CITY OF ST. HELENS PLANNING DEPARTMENT

MEMORANDUM

RE: Appeal AP.1.23 of Sensitive Lands Permit SL.2.23

Lots 9 and 10, Hanna Subdivision Appeal of Site Development Recommendation

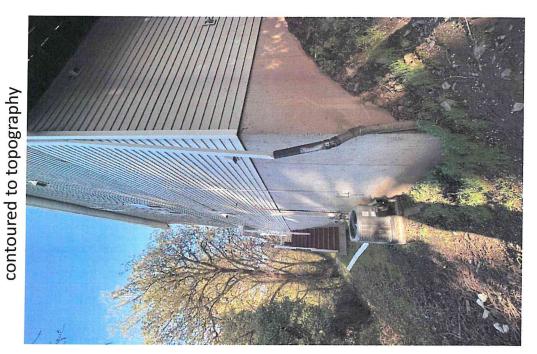
- (c) The director or approving authority shall adjust the underlying zone setback standards to the extent necessary <u>to r</u>educ<u>e</u> or minimize encroachment into the protection zone. Design shall be to this adjustment. The director or approving authority may approve up to a 50 percent adjustment to any dimensional standard (e.g., front yard, side yard or other setbacks, including height or lot area) to permit development as far outside or upland of the protection zone as is possible; and

- (d) The proposed development shall minimize disturbance to the protection zone by utilizing design options to minimize or reduce impacts of development: (i) multistory construction shall be used; (ii) parking spaces shall be minimized to no more than that required as a minimum for the use; (iii) no accessory structures allowed; (iv) paving shall be pervious; (v) engineering solutions shall be used to minimize additional grading and/or fill...

10+-foot slope with contoured foundation

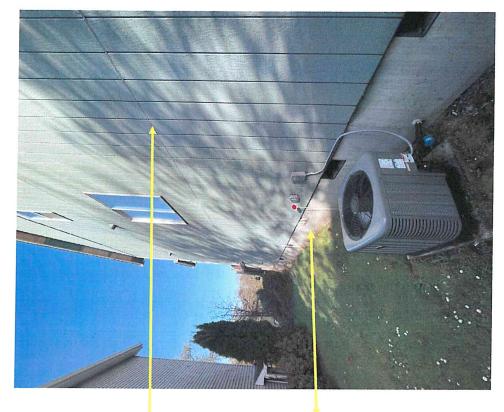
- No Environmental Assessment is included in the Site Development Application.
- No plan is provided to minimize disturbance to the Protective Zone and to minimize additional fill and grading.
- There is a clear precedent in the area for development that minimized impact The proposed construction method substantially changes the topography and the existing natural landscape. The precedent for alternative construction is at 287 N. $16^{ ext{th}}$ Street and demonstrates that a foundation contoured to the topography is of concrete barriers with backfill creates. (See example of alternate construction and does not require the use of a 12-foot wall constructed of concrete barriers. precedent exists for extraordinary site disturbance that a 12-foot wall constructed possible, while maintaining the integrity of the surrounding terrain. method the complies with SHMC on next pages.)

- Require the requisite Environmental Assessment and plan to comply with SHMC Chapter 17.40 regarding wetlands/riparian zone development within Sensitive Lands.
- provides buffering and soil stabilization should be part of this update Site structures, which do not require massive wall structures and are in Require construction methods that have been used in surrounding topography and wildlife impact. A compatible landscape plan that compliance with the St. Helens Municipal Code related to minimal Development Plan application. 7

Exhibit B – EA Map showing Protective Zone and Tree Locations

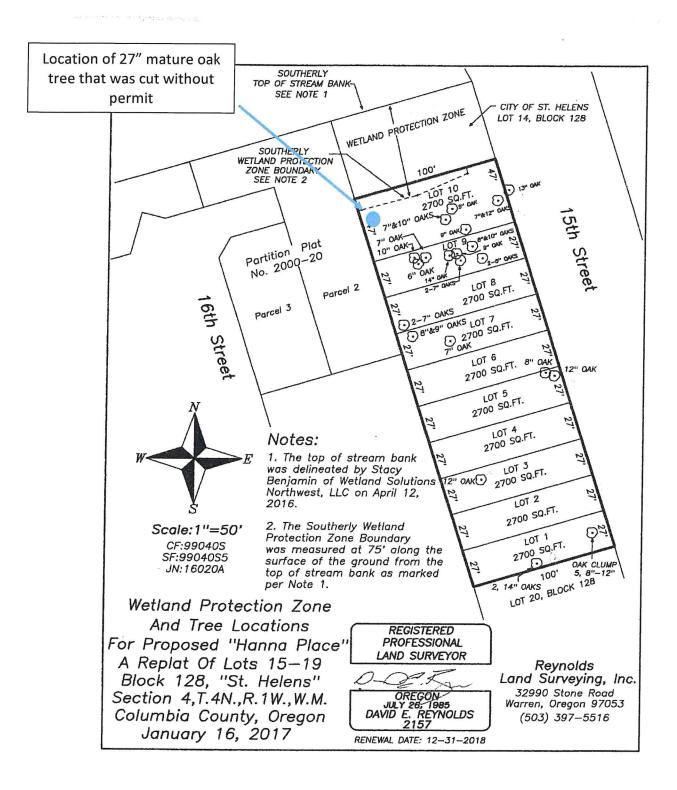
Appeal Issue #2: SHMC 17.96.180 requires that structures should be located to "preserve trees, topography, and natural drainage...and trees having six-inch DBH be preserved or replaced." Grading was done and a tree, meeting the above criteria, was felled without an approved plan or permit. (See Exhibit B – Protection Zone Map from Environmental Assessment)

Rebuttal 2A: The applicant indicated that "that's where we was going to put the wall and that's why the tree came down." No site plan permit for Site Development within Sensitive Land was approved. Therefore, the tree was removed illegally. Grading was also done without permit and the felled oak were pushed into the Riparian Zone and Protection Zone as identified by the city staff when discussing the Environmental Assessment. Additionally, the staff recommends a requirement that all "unpermitted impacts to wetlands or wetland protection zones shall be abated." However, there is no plan documentation to clearly demonstrate what the mitigation plan entails. This should be a requirement prior to final review of any complete Sensitive Land development plan.

Exhibit C - Presumed Building Location not Requiring 12-foot Structural Walls (map provided by staff)

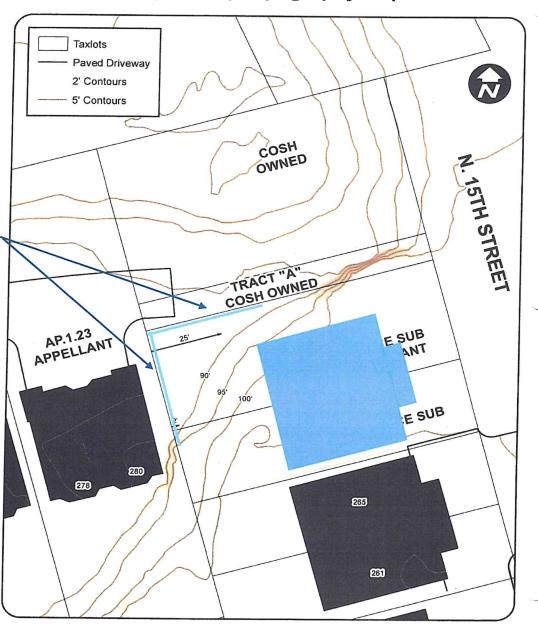
<u>Rebuttal 5B:</u> The applicant stated that the "back yard is 34 feet in back of the house." This presumably is the distance between the back of the house foundation to the property line. Because there is no plan or documentation of this claim as required by SHMC, it can only be assumed this is correct. If so, the 12-foot concrete wall proposed to be on the property line, or if set back ten feet from the property line as recommended by the staff, there is no specific justification for such a wall, since the 12-foot wall is at least 25 feet from the foundation of the house structure.
